NATIONAL PROGRAM FOR INSPECTION OF NON-FEDERAL DAMS
BUCKLEY-DUNTON DAM (M. U) CORPS OF ENGINEERS WALTHAM
MA NEW ENGLAND DIV AUG 81

BUCKLEY-DUNTON DAM
MA 00202

PHASE I INSPECTION REPORT
NATIONAL DAM INSPECTION PROGRAM

AUGUST 1981

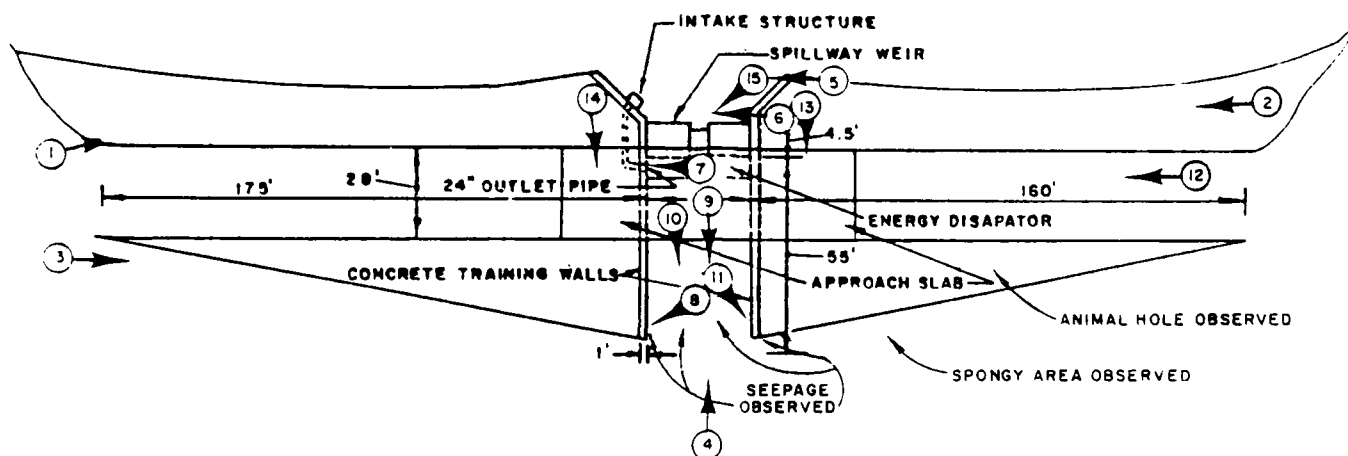
Remarks water 2" over spillway - gate partially open - seepage at toe of
embankment on both sides of spillway

Recommendations joints where spillway abuts sidewalls need to be sealed -
investigate seepage and make necessary repairs to correct

PHOTO NO. 15 - View of spillway weir.

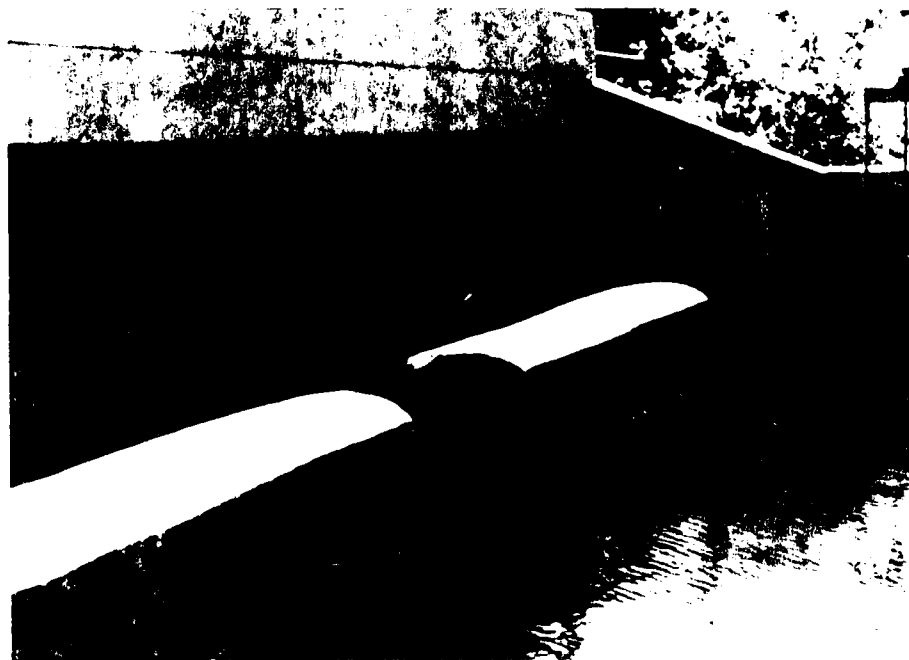
The spillway (photograph 15) consists of a 35 foot long concrete weir, upstream and downstream concrete training walls, a concrete deck service bridge, an energy dissipator and a mortared stone apron. The weir contains a central 5 foot long, 1'-6" deep drop section (photograph 15). It contains no
